**Amendment Report for the Application of Substantive
Amendments to the Environmental Authorisation issued for
the development of the 140 MW Rietrug WEF, Sutherland,
Northern Cape Province**

DEA Reference number: 12/12/20/1782/1/AM2

February 2017

Figure 2. Proposed amendment layout (green dots) and approved layout as per the EA obtained in 2016 (black dots)

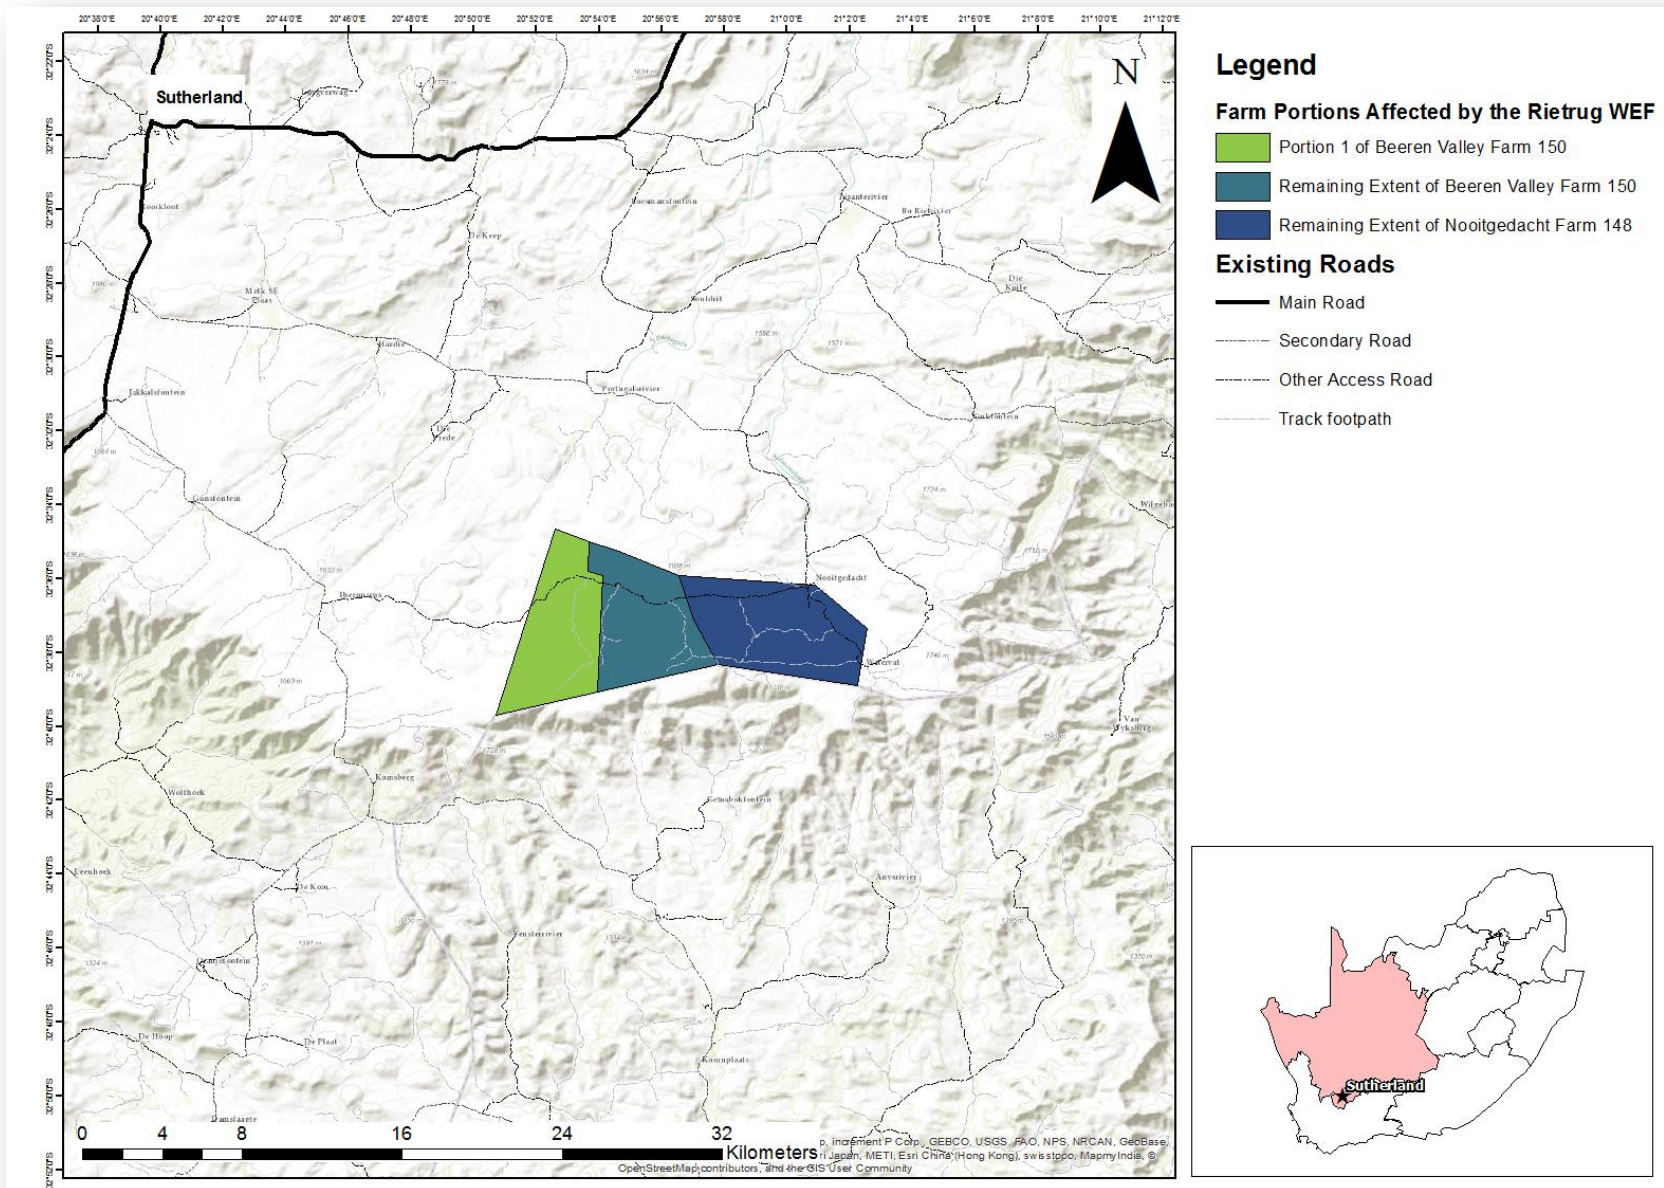
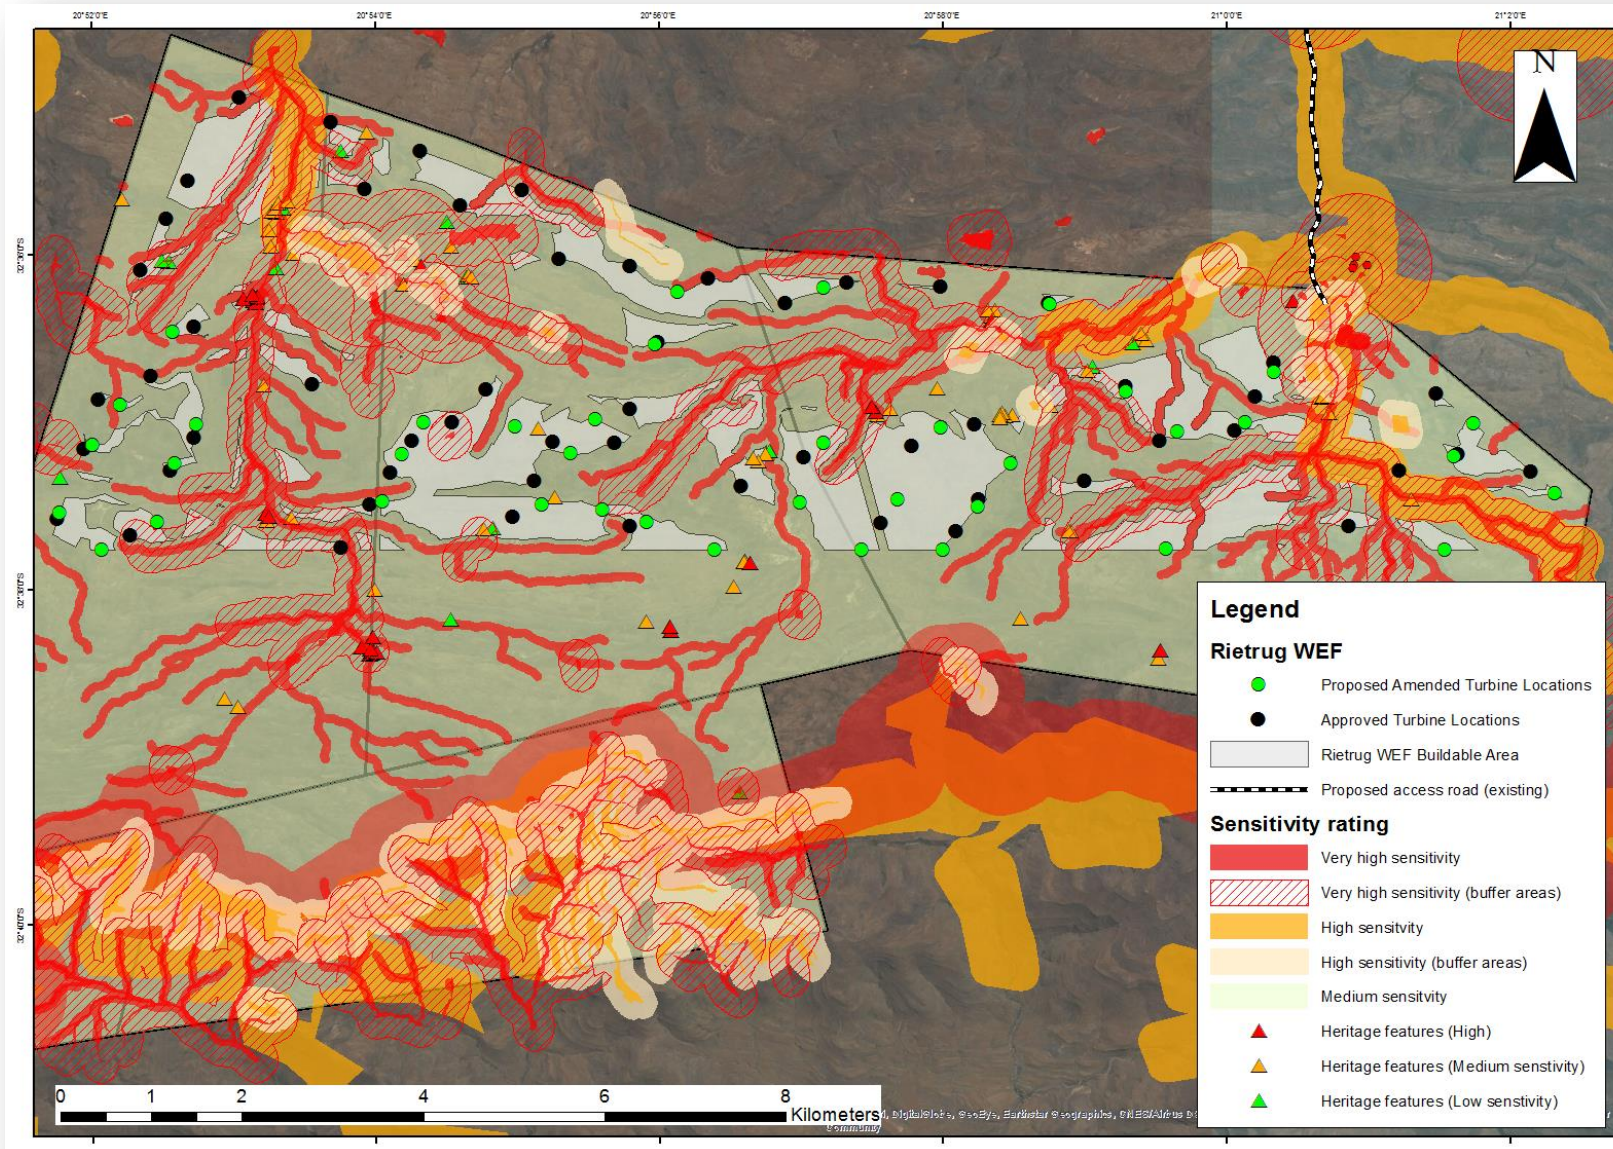
The turbine technology available for the authorised specifications, i.e. a 120 m hub height and rotor diameter, is no longer the preferred wind turbine technology since these have become obsolete and more efficient turbines (i.e. megawatt output per turbine) is now available in the market. Mainstream therefore wishes to amend the authorised turbine specifications to up to 150 meter hub height and up to 150 m rotor diameter which is aligned with the preferred turbine technology currently available in the market. In addition to this, due to the proposed amendment in turbine specifications, the authorised layout will also change to accommodate the larger turbines.

The authorised turbine layout and associated road network and the proposed amended layout are shown in Figure 2 below. This map includes the various environmentally sensitive features that were considered as part of the original EIA (2011) and the amendment process (2016) and also the buildable area that was determined based on these sensitivities. The buildable area is effectively the 'development envelope' for this development whereby no turbines may be placed outside the boundary of the buildable area. The amended layout avoids all sensitive features that were identified on site and occur within the buildable area that was determined.

Figure 5. Projected conceptual noise rating levels of the Rietrug WEF during operation (De Jager, 2017)

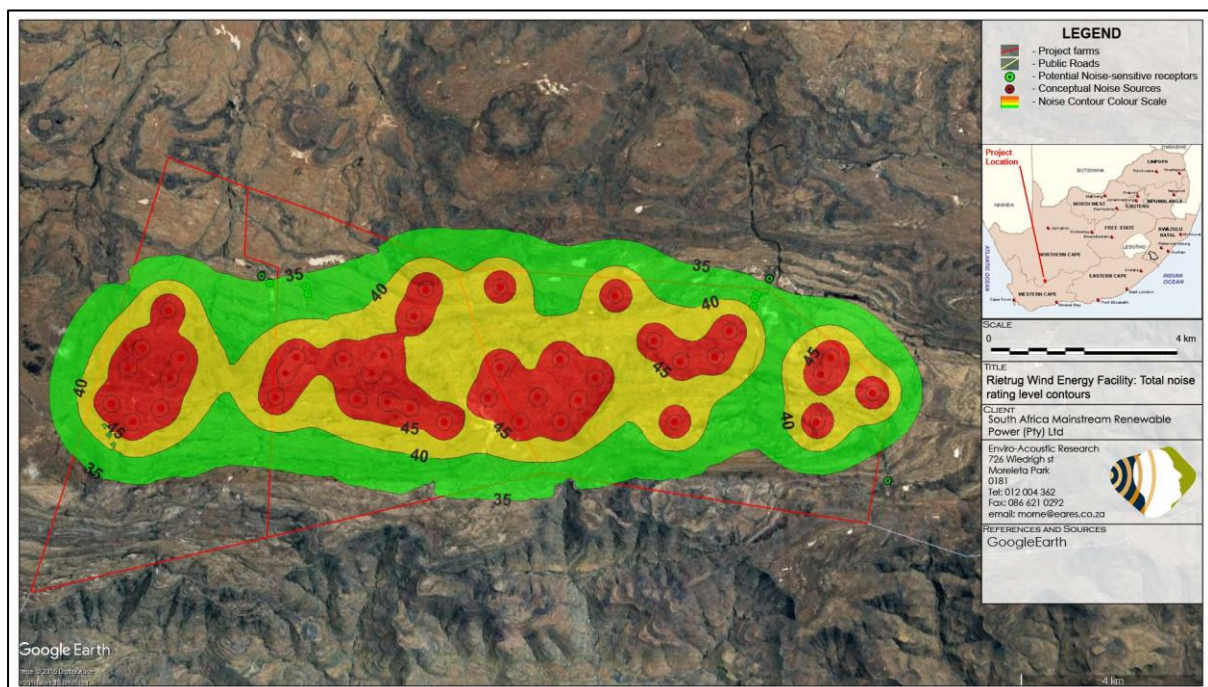
With the modelled input data as used, this assessment indicated that the potential noise impact would be of a **very low significance during the construction and operational phase**. Please refer to Figure 5 below for the project noise rating levels of the Rietrug WEF during operation (assuming the turbine height is 150 m and the rotor diameter is 150 m).

Figure 6. Projected conceptual night-time cumulative noise rating levels (Rietrug WEF and other WEFs in area) (De Jager, 2017).

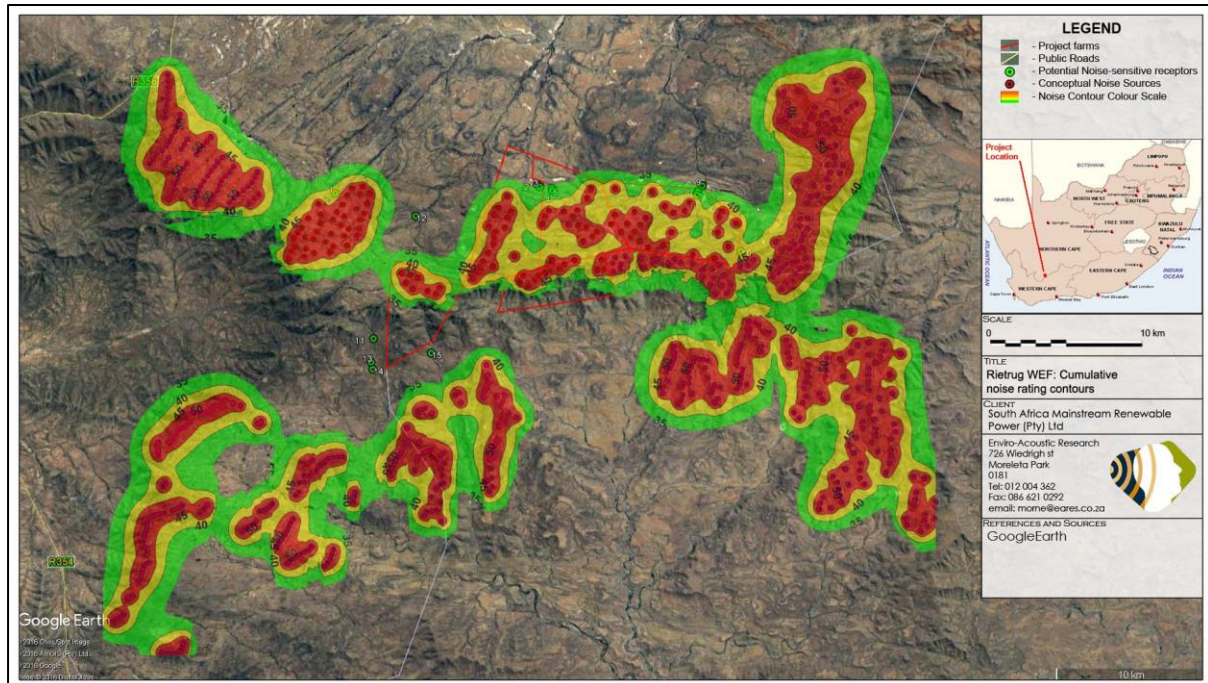
Cumulative noise impacts generally only occur when noise sources (such as other wind turbines) are closer than 2,000m from each other (around 1,000m from the conceptual receptor located between them). The cumulative impact also only affects the area between the wind turbines of the various wind farms. **The addition of the Rietrug WEF will not result in a cumulative noise impact significance and the cumulative noise impact will be very low.** Please refer to Figure 6 below for the cumulative noise rating levels.

Figure 8. Cumulative viewshed for the Rietrug WEF with 150 m high wind turbines (Holland, 2017)

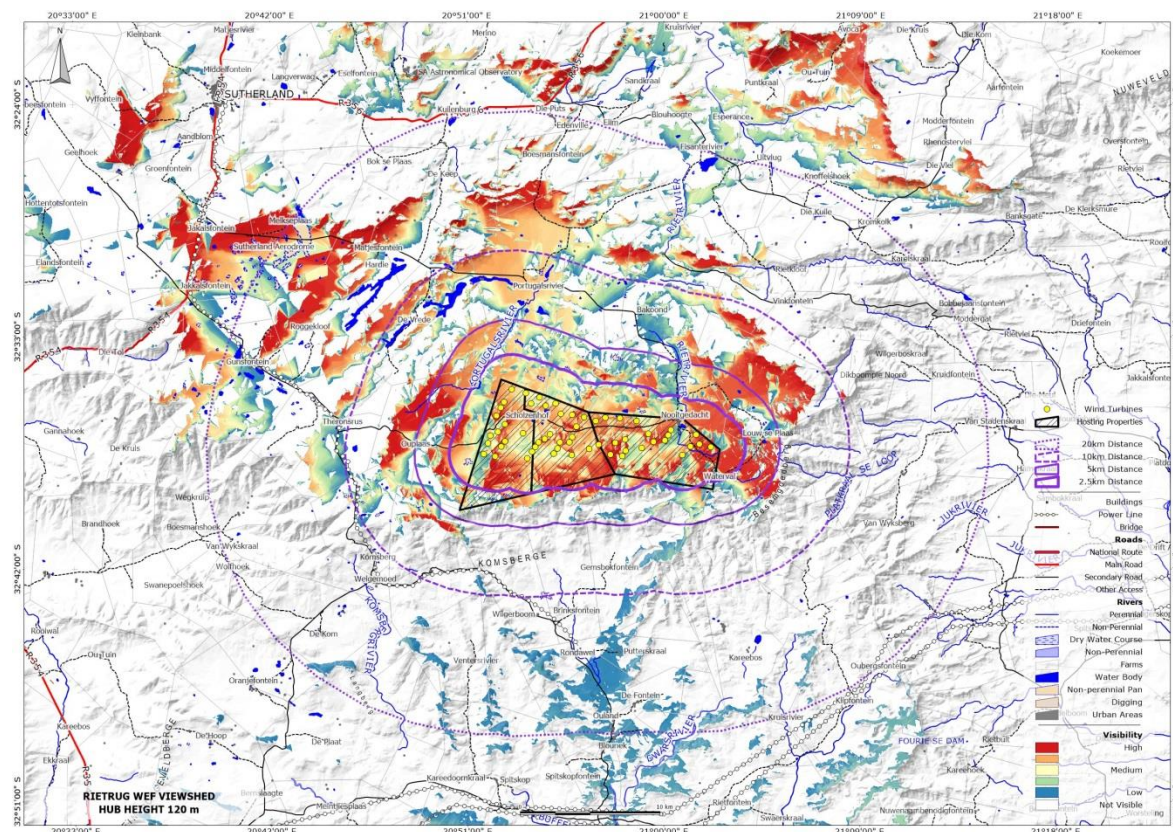
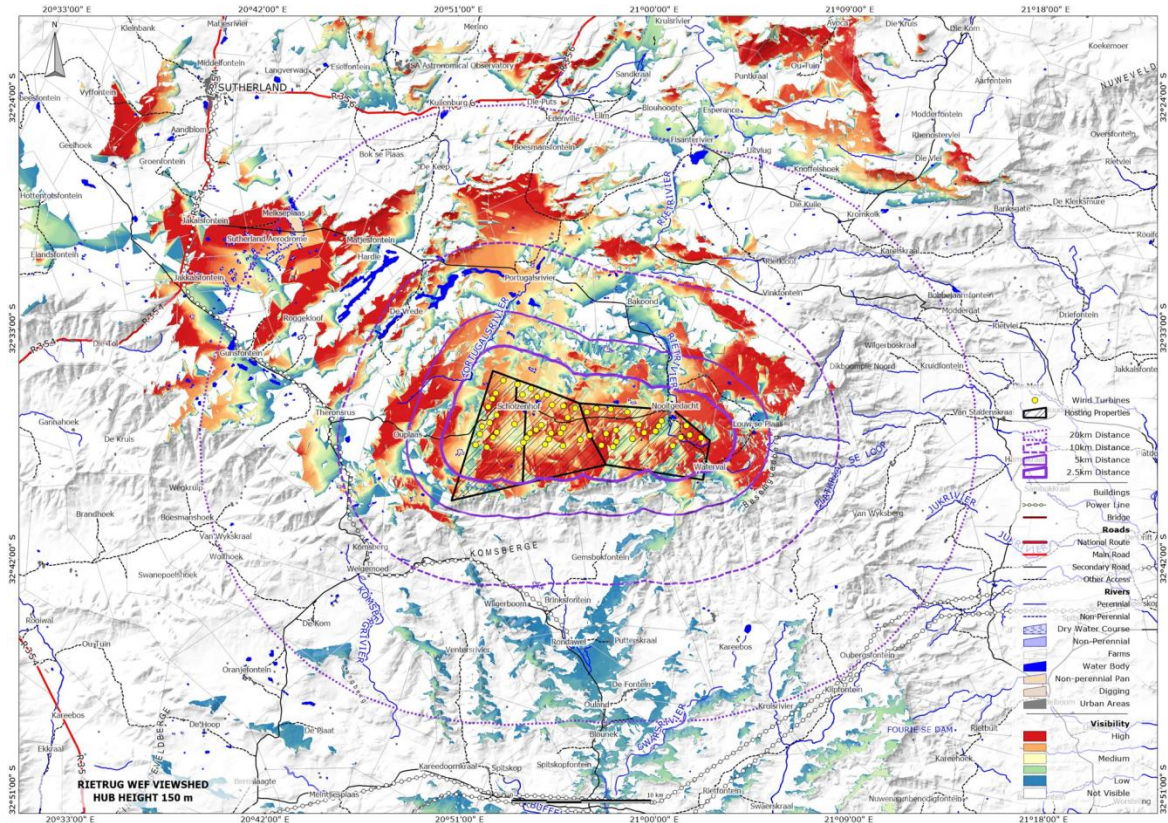
The viewshed analysis shown in Table 3 above and in the figures below (Figure 7 and Figure 8) provides an indication of the potential effect that a change in turbine height may have on the significance of visual impacts as discussed in the original VIA Report. It is clear from the results that there is very little difference in viewshed area as well as the number of potential sensitive visual receptors that will be highly or moderately exposed to wind turbines. The change in number of buildings (as proxy for sensitive visual receptors) for moderate and

high visual exposure is, in all three cases, limited to farmsteads. In other words, the change in turbine height will not affect a higher number of farmsteads. There will be a few more buildings at some of the farmsteads that will potentially be highly exposed to the 150 m wind turbine and only moderately exposed to the 120 m wind turbines. Many of these buildings are not residences but other farm buildings. The most significant change occurs at distances beyond about 8 km from the turbines. For instance, there are 13 buildings for which 120 m turbines will not be visible but which will have low visual exposure to 150 m turbines. **In general, due to topography, the number of wind turbines and the height of wind turbines, an increase in turbine height will only affect visual receptors further away in that the rating might change from 'Not Visible' to 'Low' visual exposure.** The topography of the region, although highly varied, cannot efficiently hide structures of this height and number.

The change in height of wind turbines from 120 m to 150 m will not introduce any new visual impacts and the significance of potential visual impacts as assessed in the original VIA Report will at worst remain the same (for all three projects combined – there will be fewer wind turbines to cause visual impact, as per the EAs issued in 2016 compared to the 2011 project layout). The original VIA Report (Oberholzer and Lawson, 2011) rated the visual impact on fixed positions and temporary receptors as High before mitigation with residual impact significance after mitigation as Medium-High. Mitigation measures listed in the VIA Report remain valid and include:

- A visual buffer of 500 m for the wind turbines from the local district roads.
- A 250 m setback of the wind turbines from farm boundaries should be observed.

Figure 9. Environmental sensitivity map overlay with the amended turbine locations for the Rietrug WEF

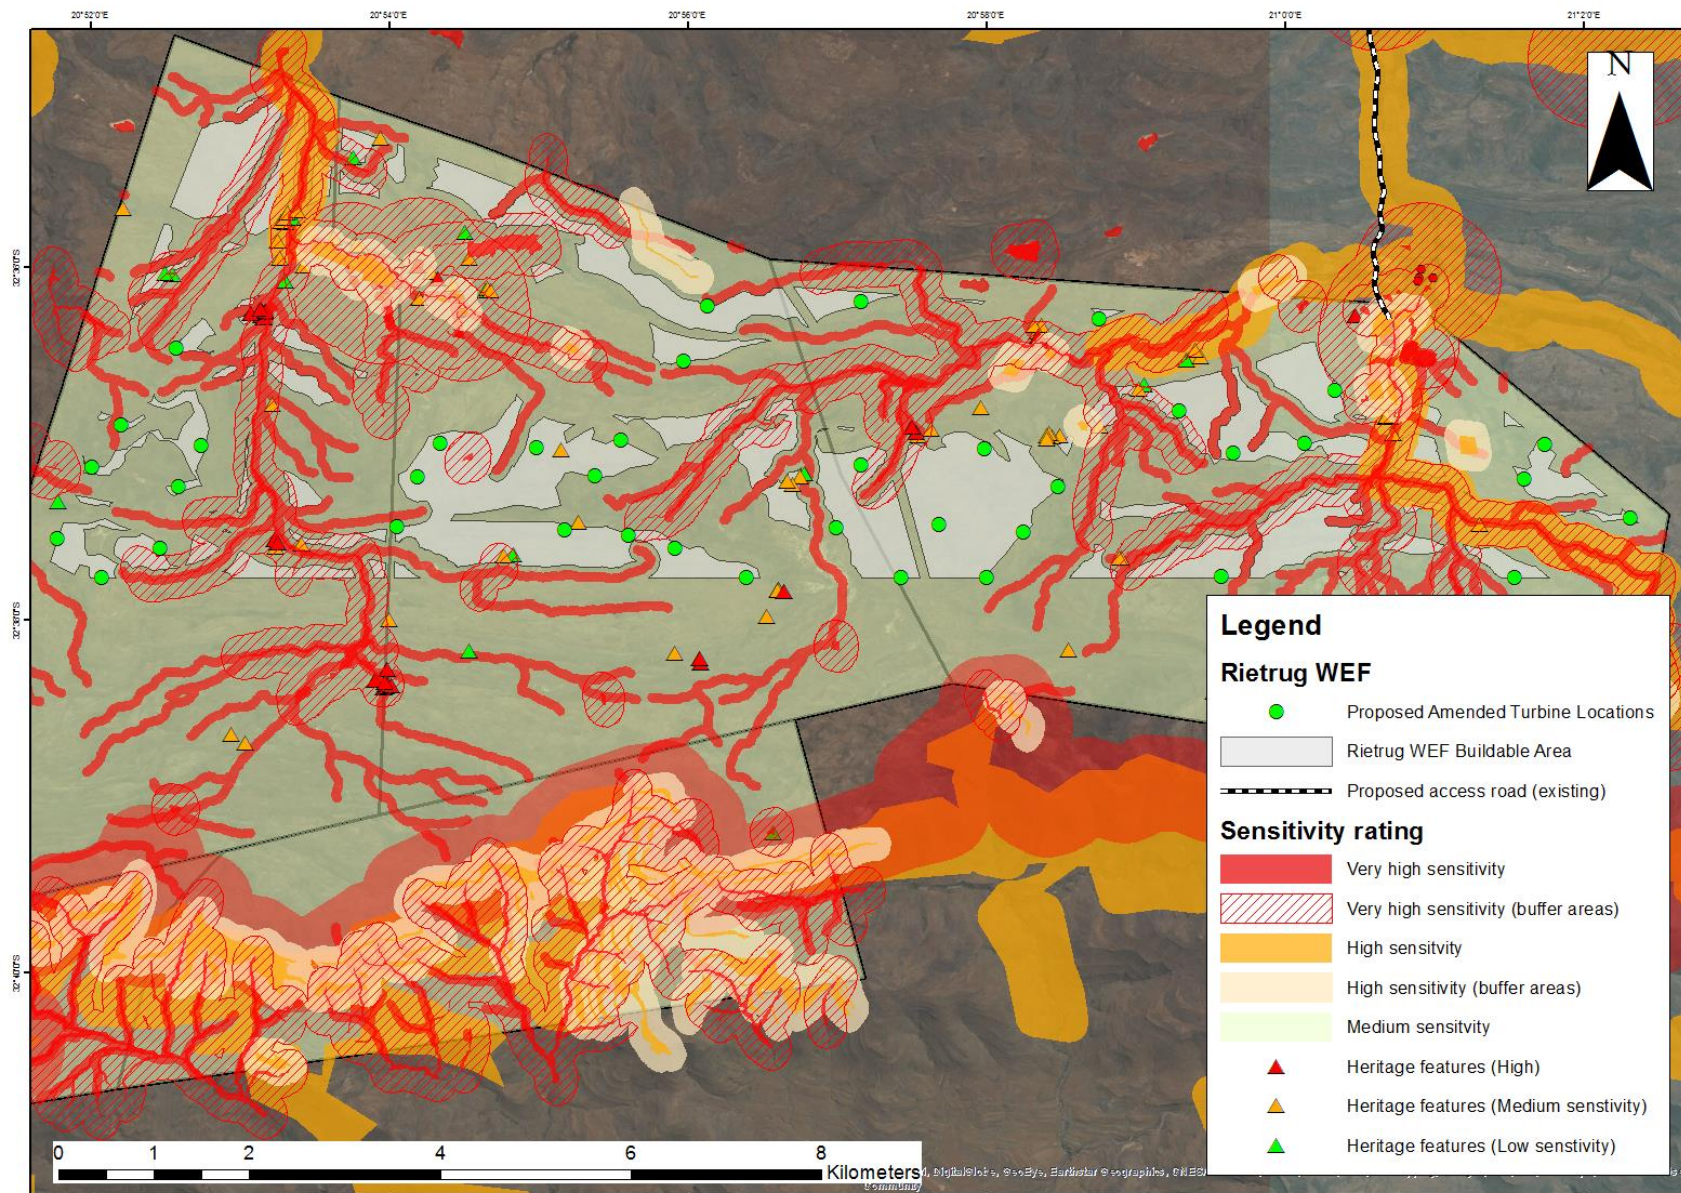
Based on the studies outlined above and the findings thereof, a map has been produced (Figure 9) to show all the environmental features and their respective buffers (where applicable) that were identified by the various specialists. The map, in turn, was used to determine the buildable area of the WEF. As stated previously, the buildable area is the development envelope of the Rietrug WEF which determines the development constraints for this project.

The proposed amended layout, which incorporates the larger turbines, avoids all environmental features that were identified on site, avoids areas that were recommended by the specialists in the previous section and adheres to the provisions included within the EA issued.
